工程指示 / 要求簡箋(E.I.)

工程指示編號：EI / 4943 / 22

工程名稱：將軍澳日出康城

工程項目：T3 幕牆單元件 廠用玻璃 BM (9/F-65/F)

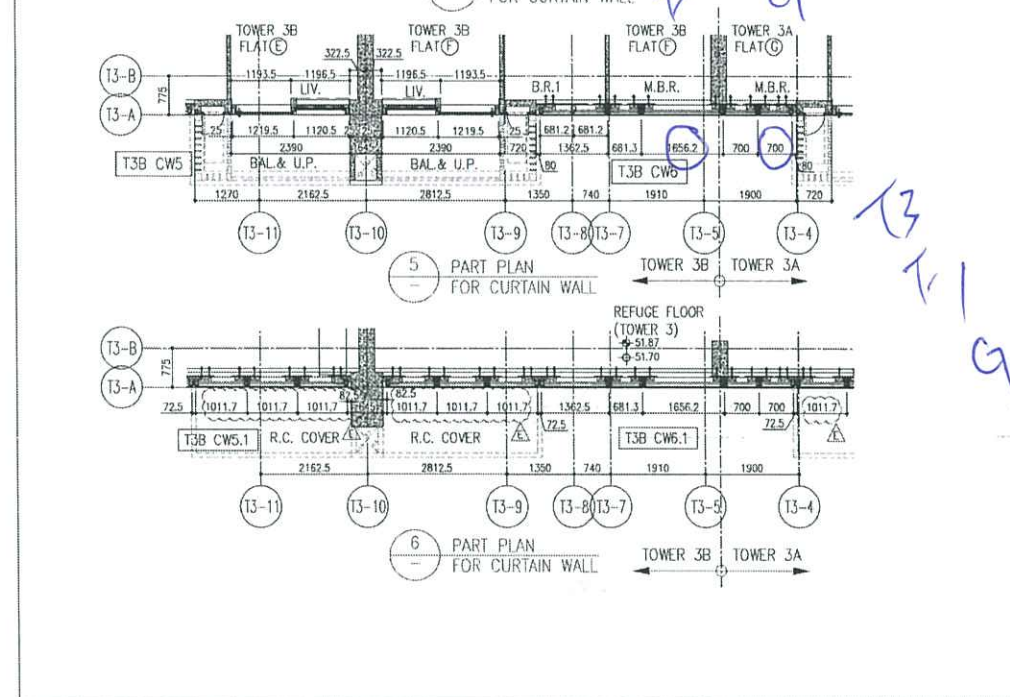
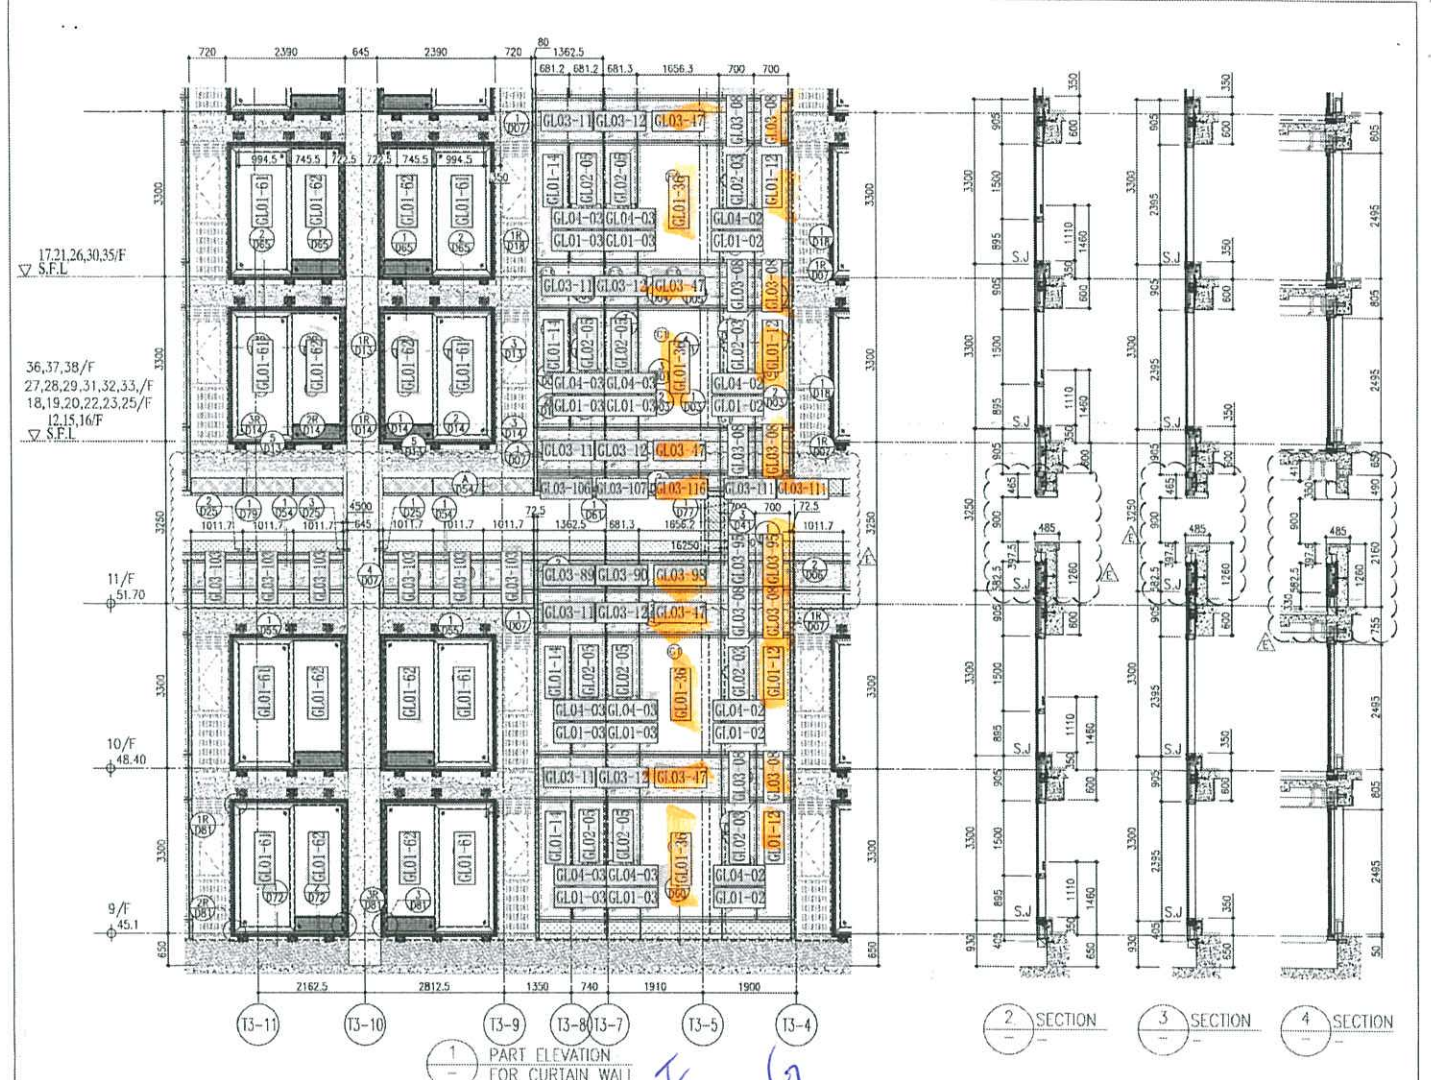
A：因應則師修改尺寸，導致玻璃尺寸修改。

此 1 柱 (2 個派倉) 共 204 件受影響：按時進度 T3 玻璃 尚未有生產和熱浸。

T3A CW2 已減走 4 件

7144.
- 6940.

204

請按玻璃 BM 生產玻璃送廠。按 MTR 業主要求，需做 QR Code 追蹤玻璃，由本 EI 開始。
